## Historic Preservation Board Staff Report

**Author:** Hannah M. Tyler, Planner  
**Subject:** Reorientation and Material Deconstruction Review  
**Address:** 424 Woodside Avenue  
**Project Number:** PL-16-03379  
**Date:** July 19, 2017  
**Type of Item:** Administrative – Reorientation (Rotation and Lifting) and Disassembly/Reassembly (Panelization)

**Address:** 424 Woodside Avenue  
**Zoning:** Historic Residential (HR-1) District  
**Designation:** Significant  
**Applicant:** Jon and Heather Berkley (Represented by Jonathan DeGray, Architect)  
**Proposal:** (1) Reorient the Historic Structure towards Woodside Avenue (west). The primary façade of the Historic Structure currently faces towards Main Street (east), and the applicant is proposing to reorient the building 180 degrees towards Woodside Avenue. The Historic Structure will be lifted 7 feet 7 ¾ inches upon reorientation.  
(2) Panelize the Historic Structure in order to facilitate the reorientation.

**Figure 2a:** *Proposed Reorientation – West Façade*

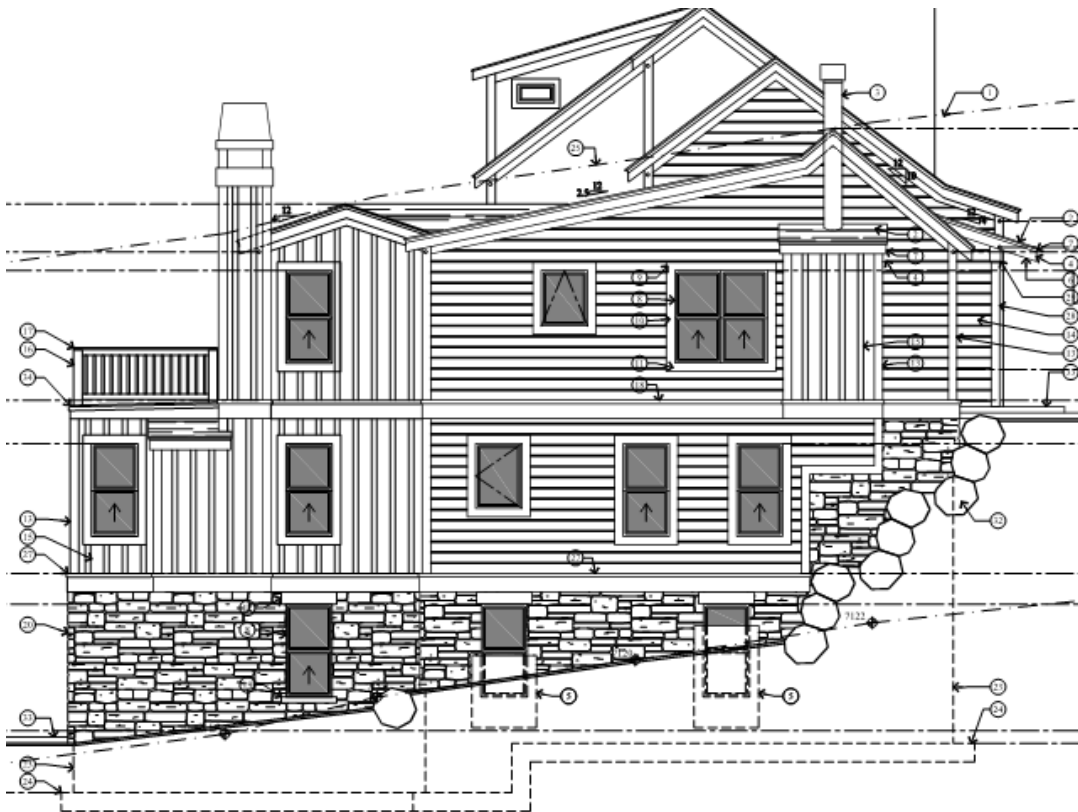
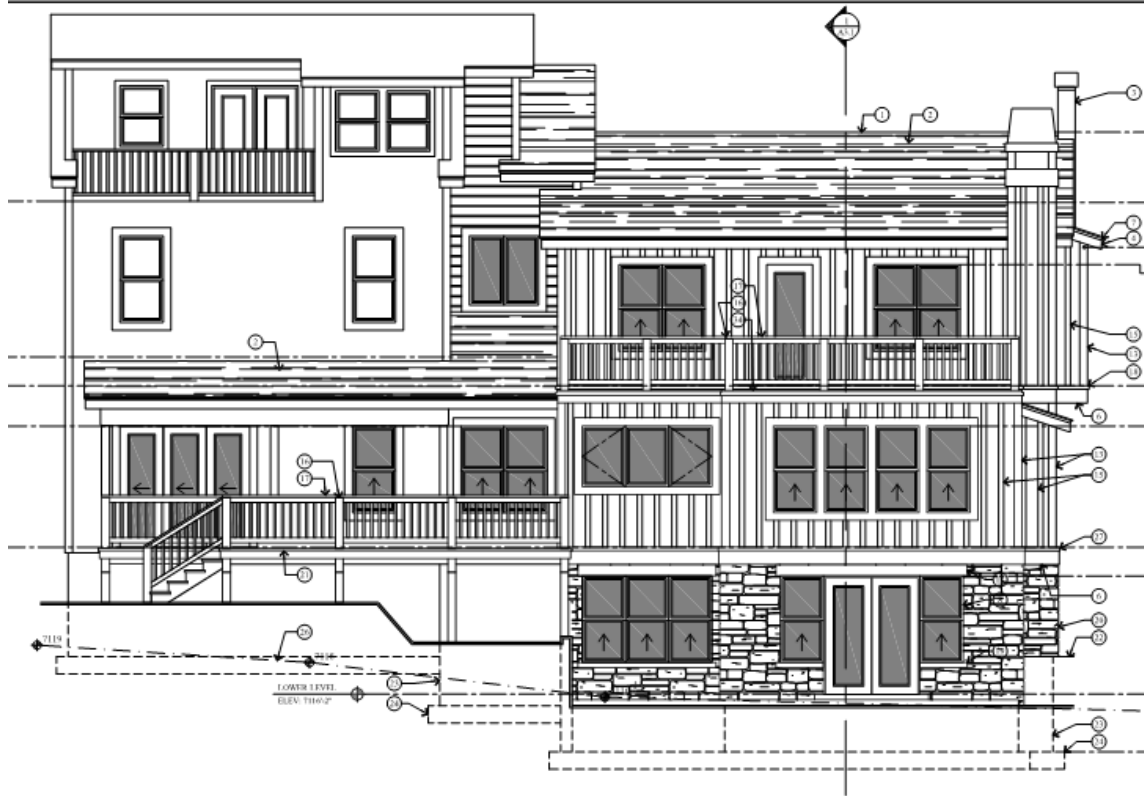
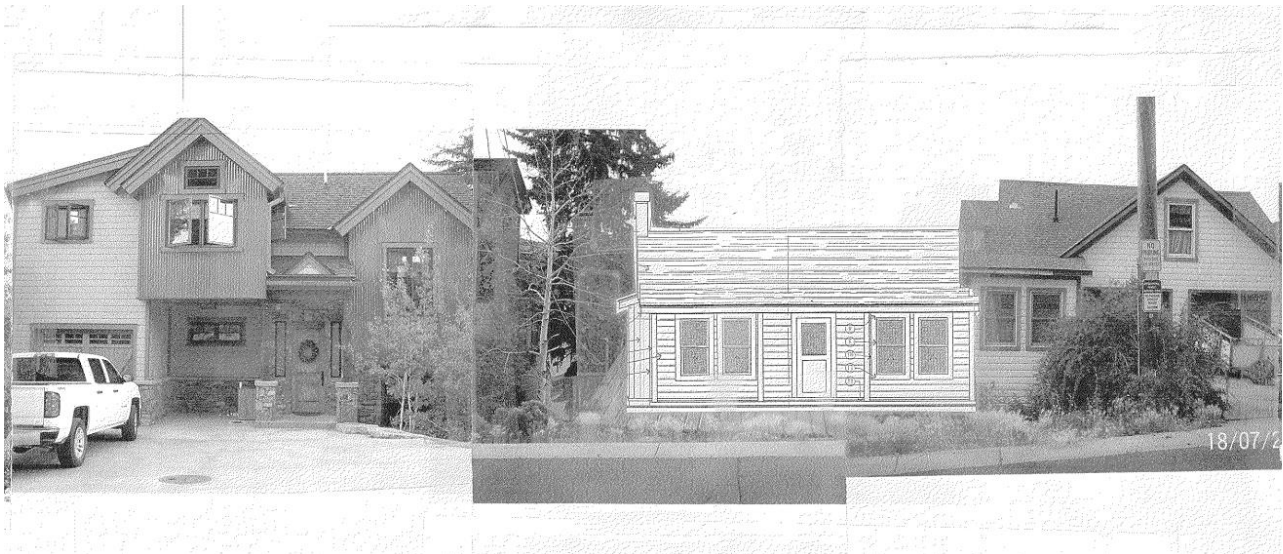
*The proposal does not comply as although the applicant has submitted a plan for rotation and staff will require a Structural Engineer’s report, the structure is currently structurally sound and panelization is only necessary to facilitate the proposed reorientation.*

*The Planning Director and Chief Building Official do not find unique site conditions that would warrant a disassembly and reassembly. The structure is currently structurally sound; however the proposal to reorient the structure towards Woodside Avenue would result in the disassembly/reassembly (panelization) of the structure. While there is limited space between the neighboring property and the 1993 addition, staff finds that the current orientation of the structure would facilitate redevelopment without harming the historic structure or creating the potential for further historic material loss.*
